VCPS - New School

210 12th Street NE, Valley City, ND 58072
Project #: 24-028
Addendum 01
03/17/2026

SHEET
C400

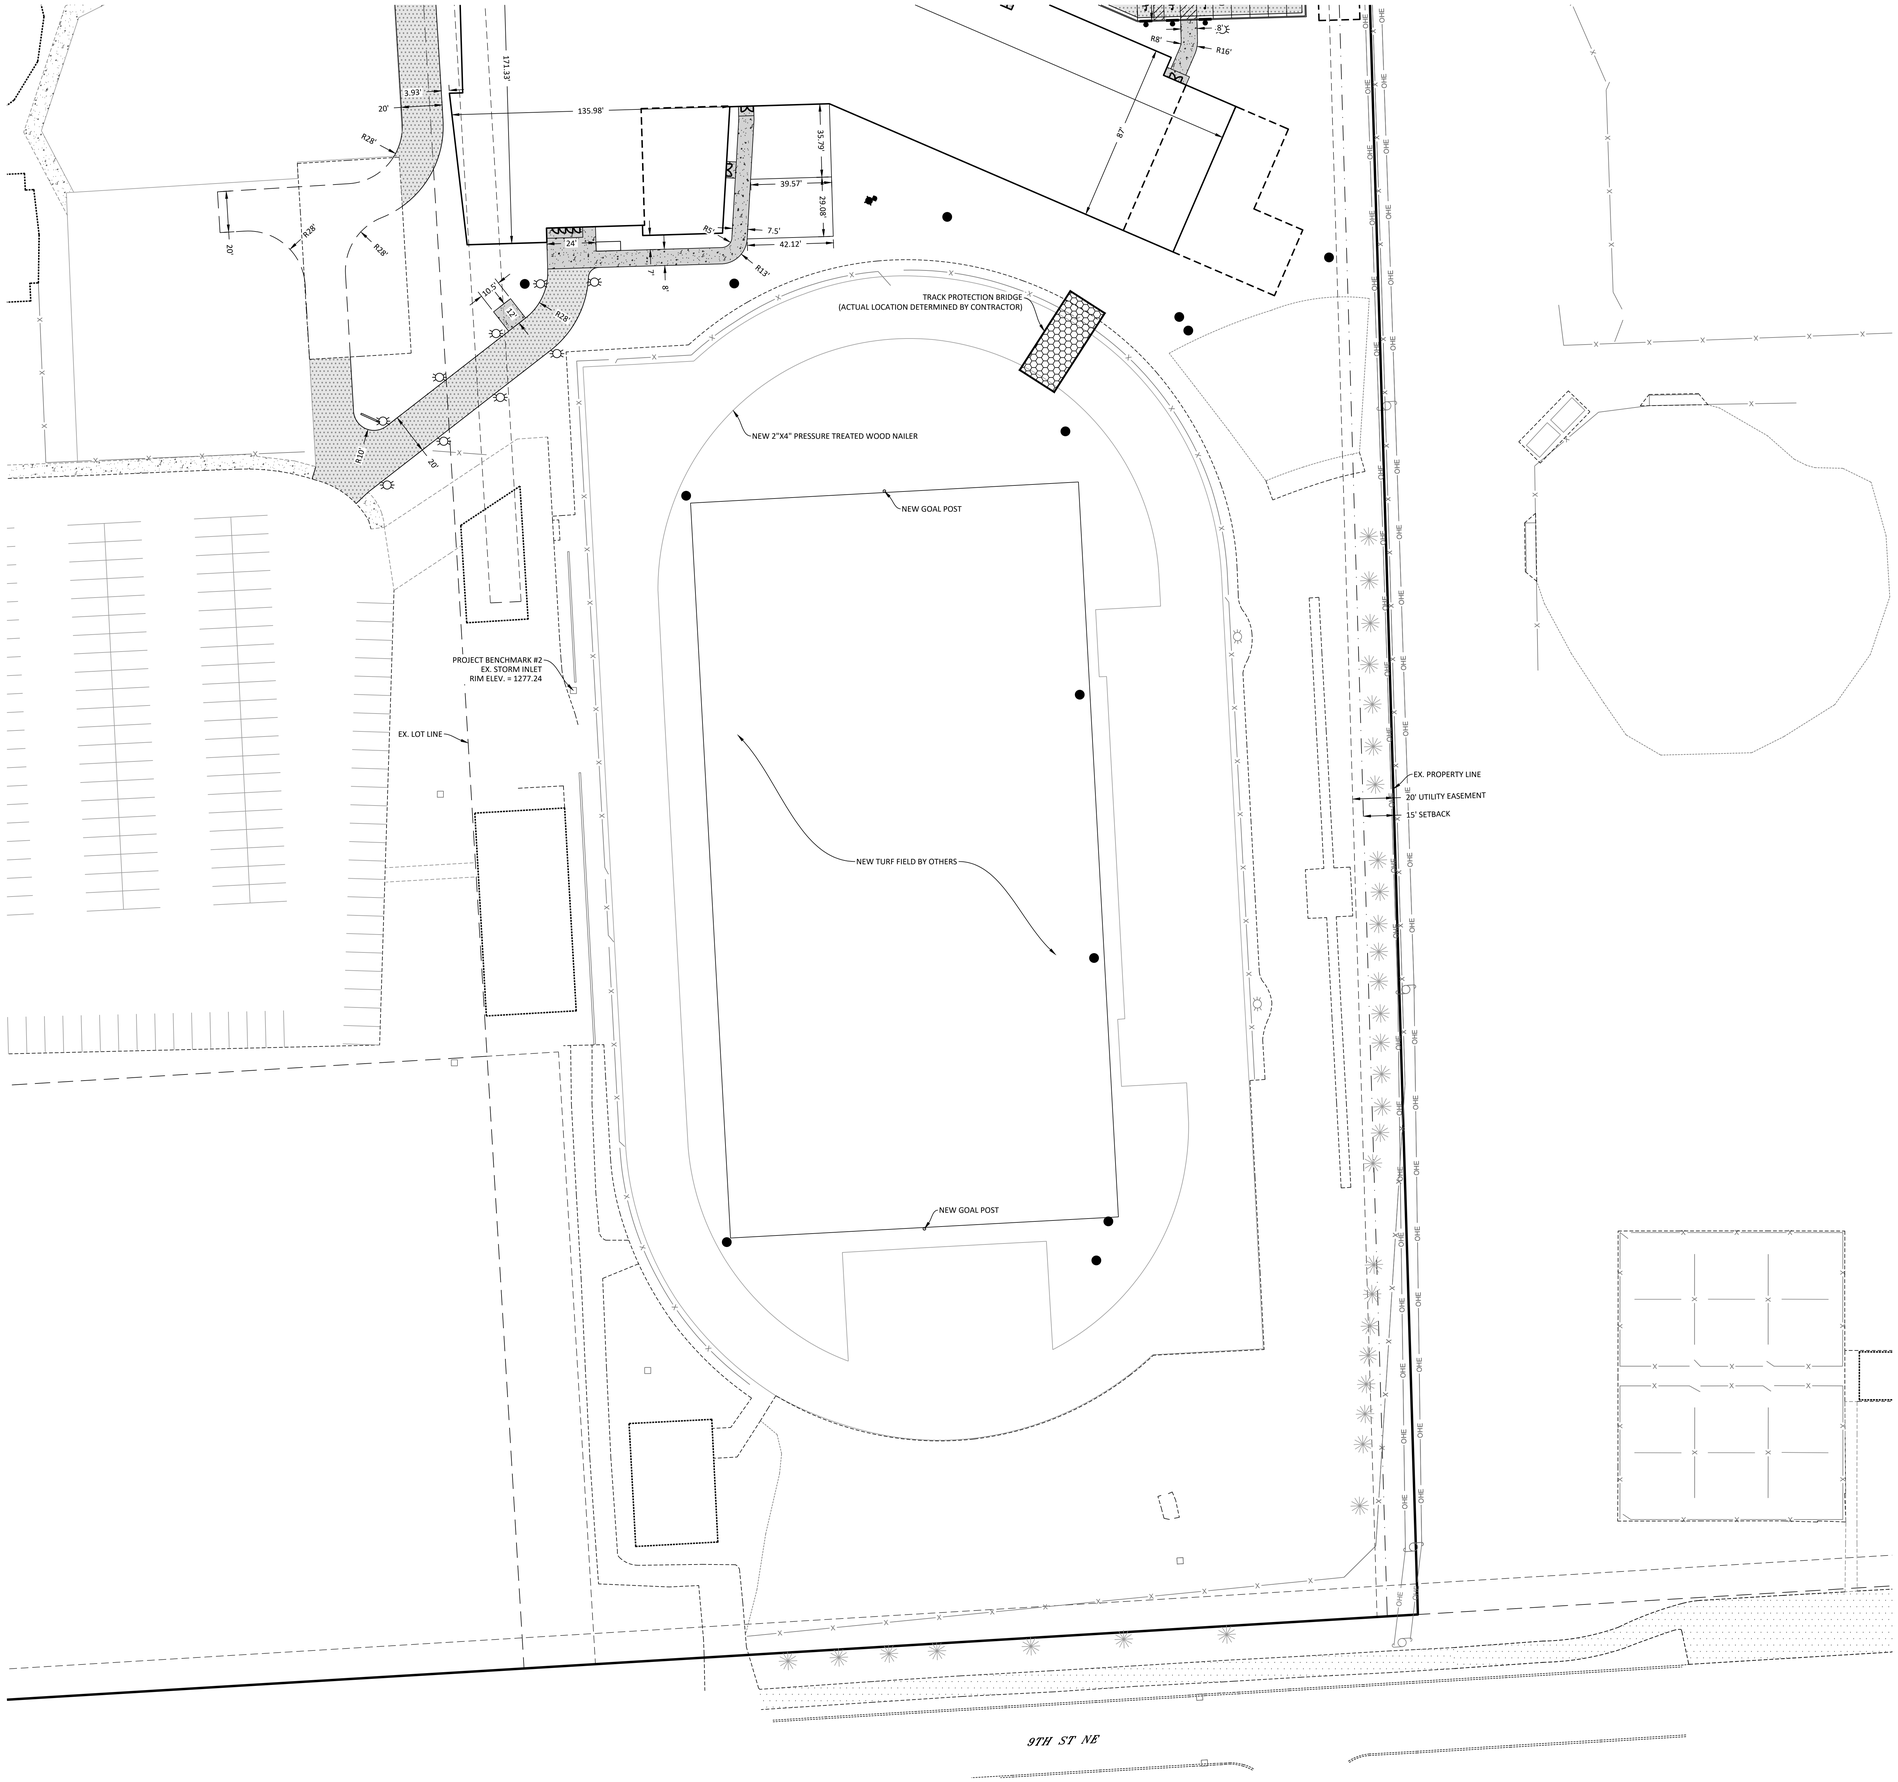
1. Revised asphalt fire lane
2. Revised building footprint
3. Revised south door sidewalk width
4. Revised patio alternate dimensions

5. Revised highway guardrail location
6. Added light pole locations
7. Added Transformer and CT cabinet locations
8. Added note about segmental block wall
9. Added “do not enter” sign
10. Added ADA parking sign callout

SHEET
C401

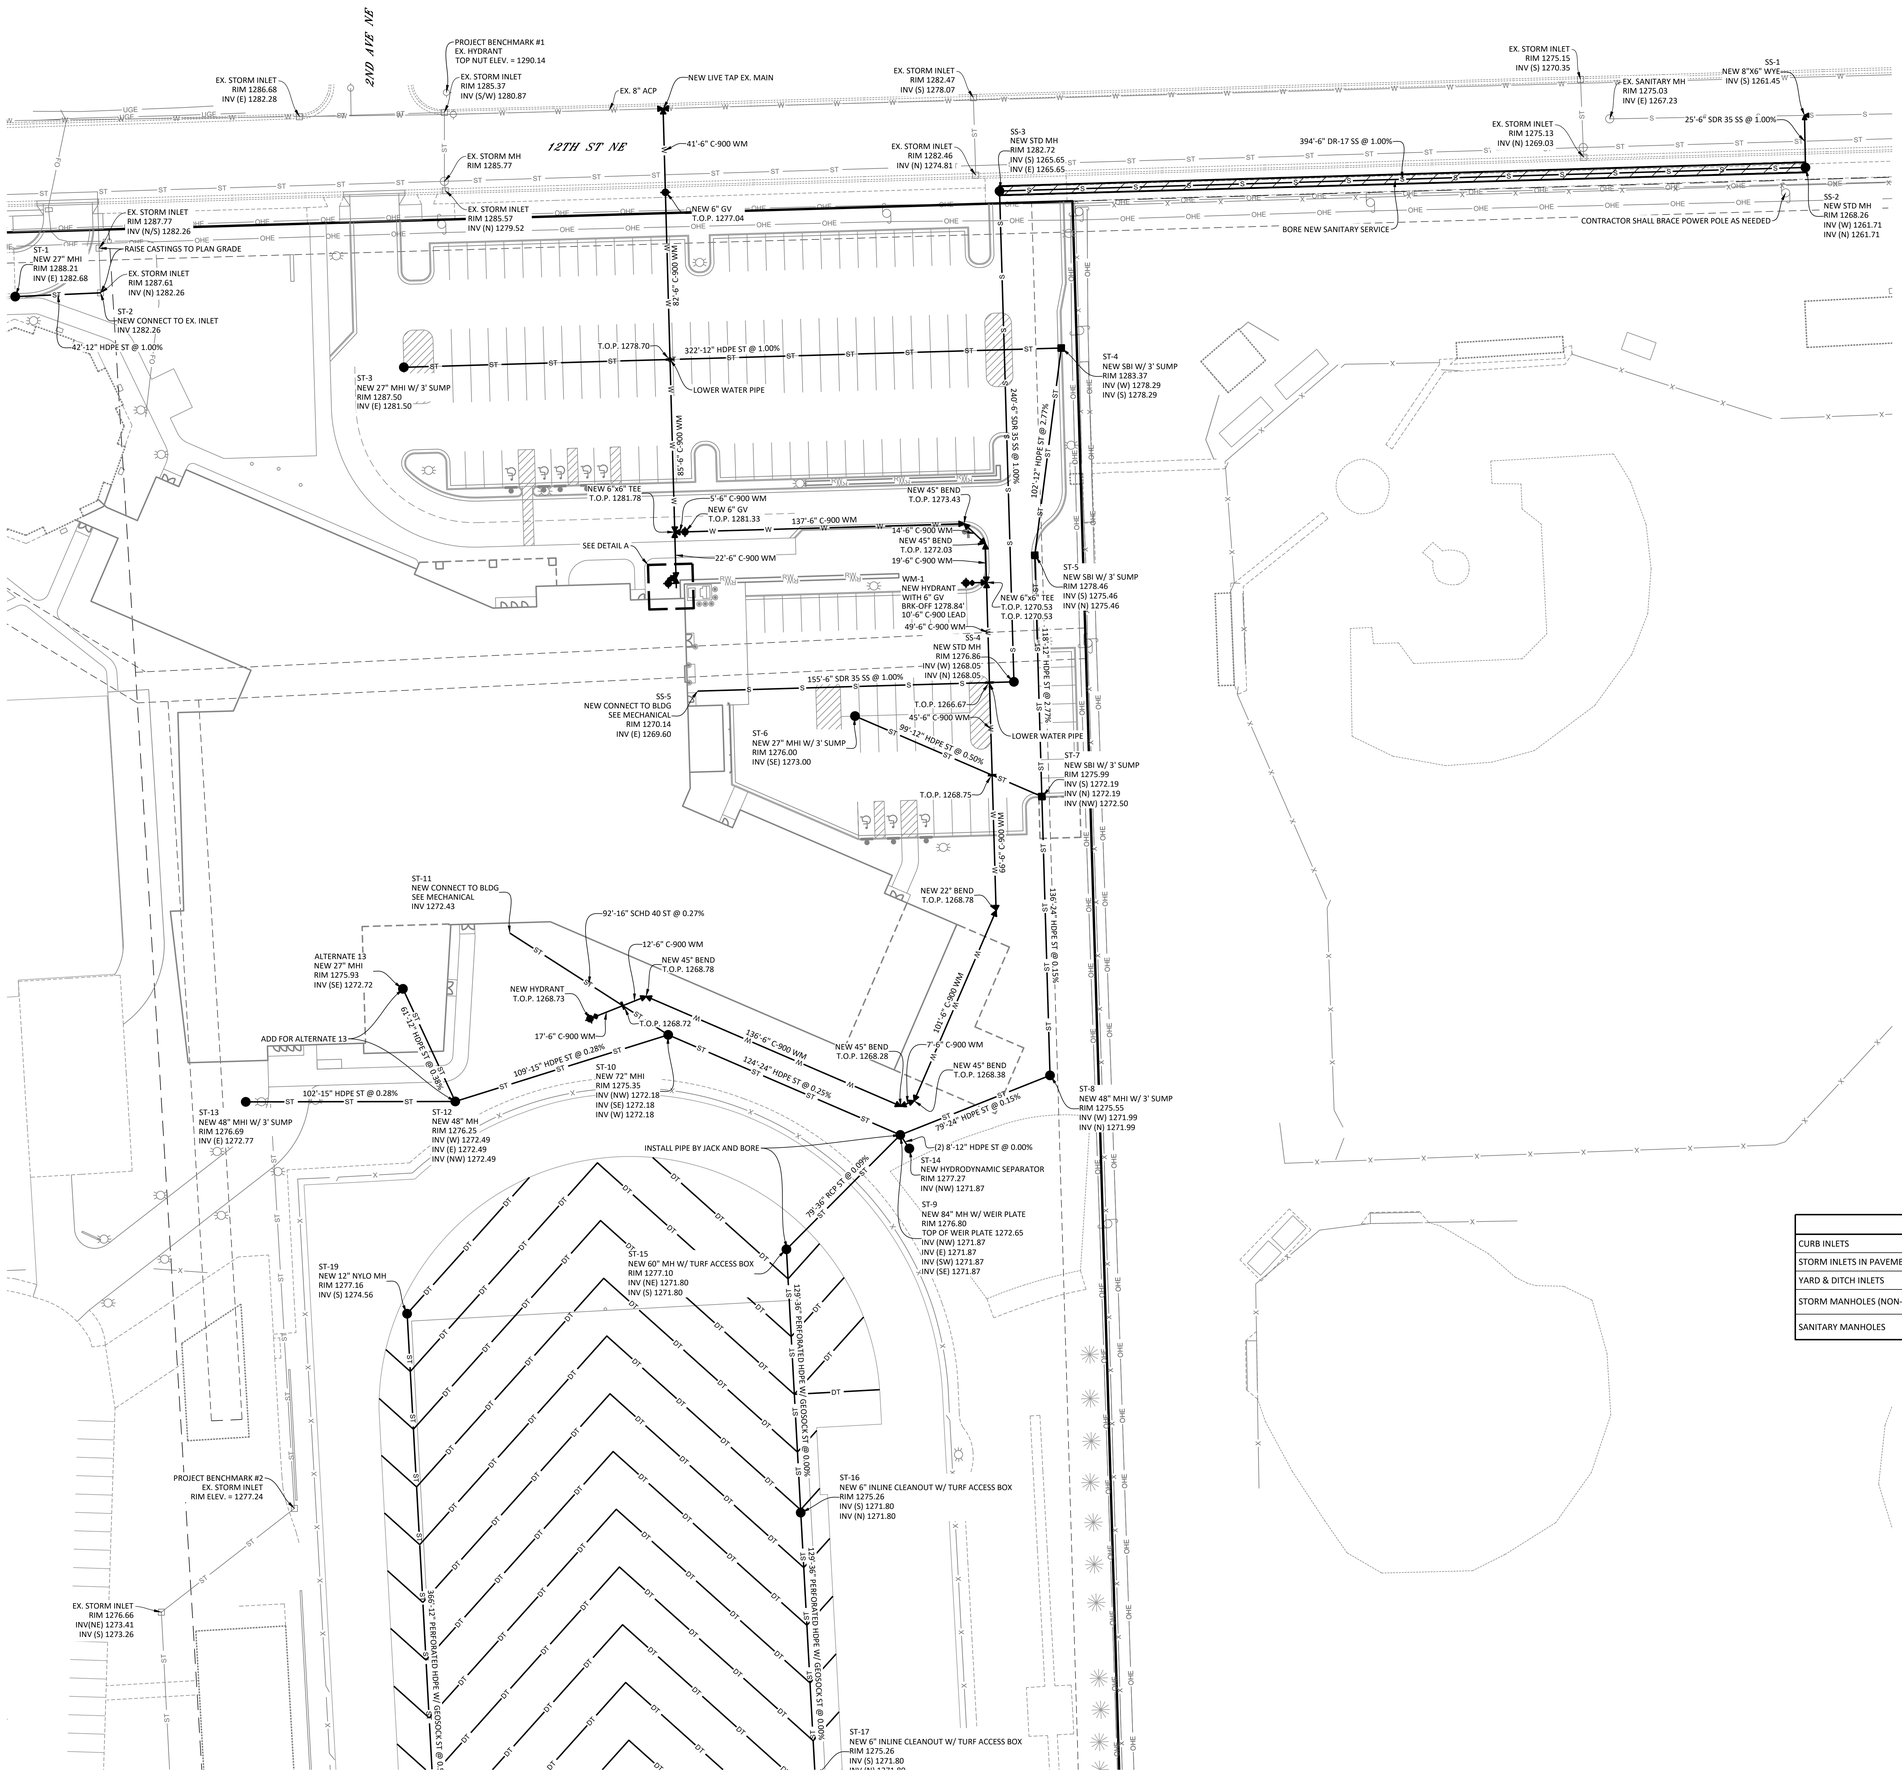
1. Revised background

P1 S303 Pier

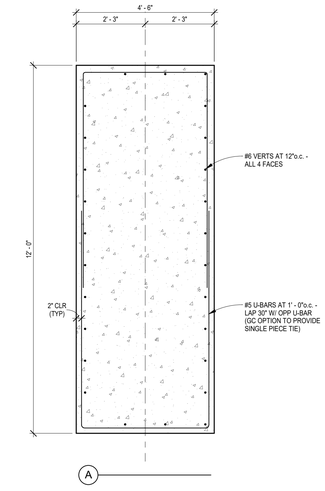
1. Added detail 4/S303 for canopy pier.

SHEET
A111C

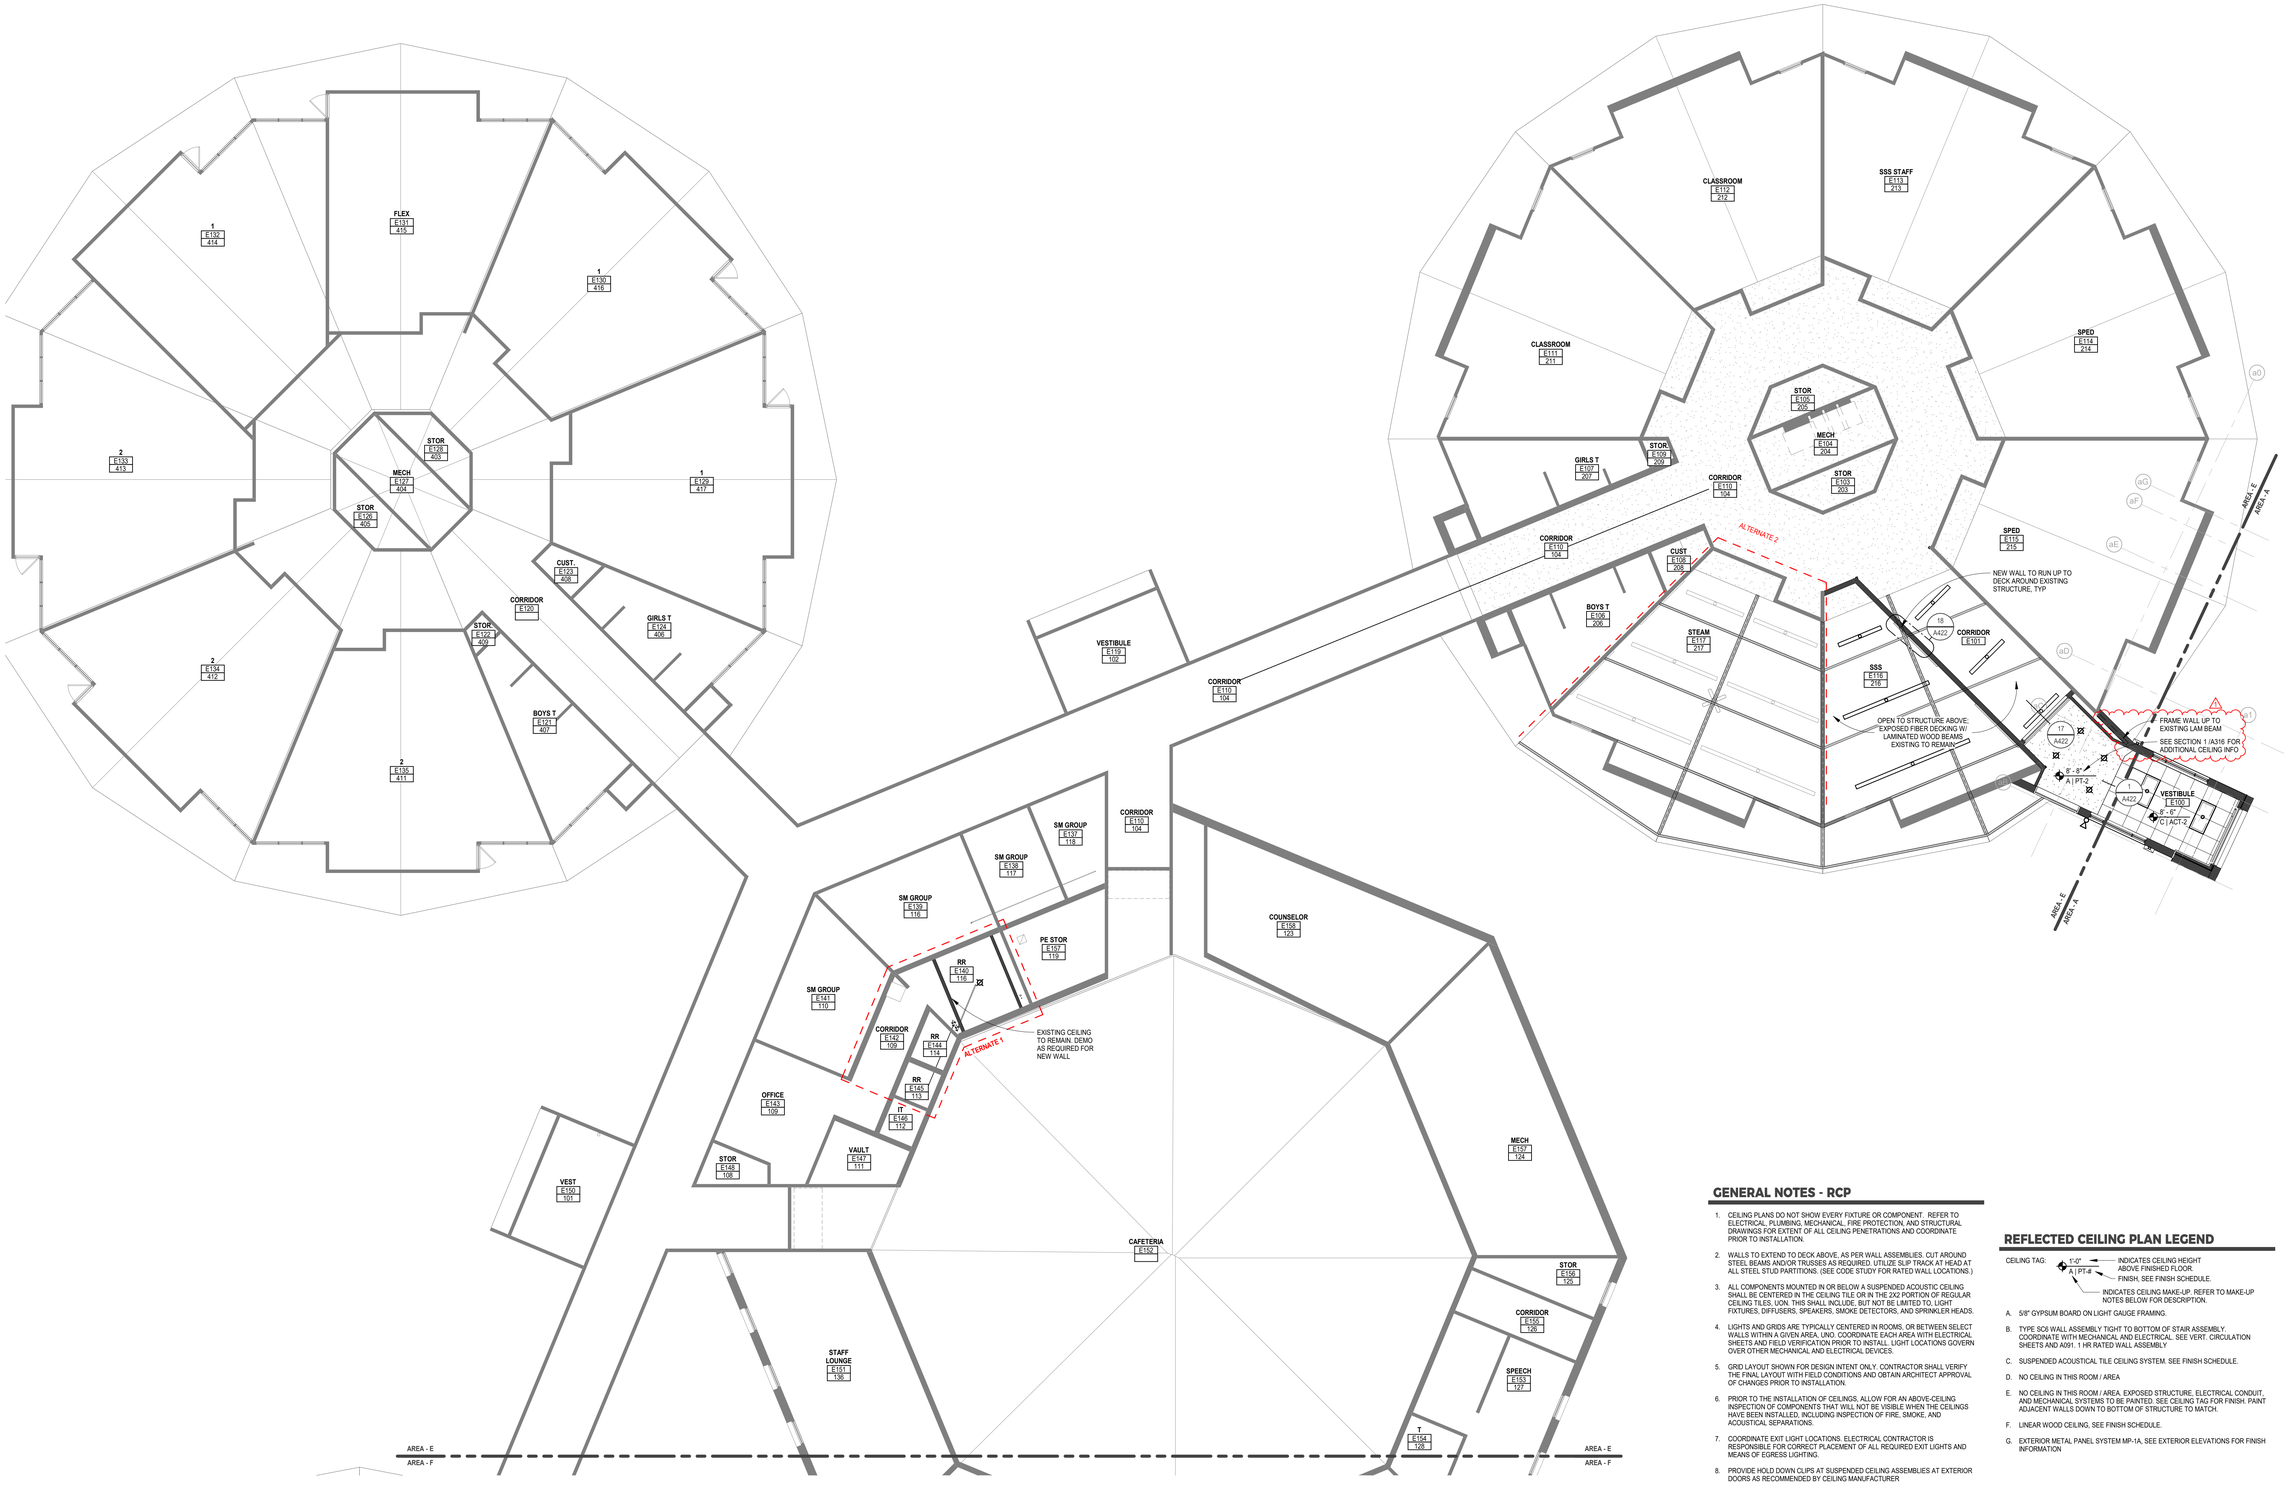
1. Added an access panel.
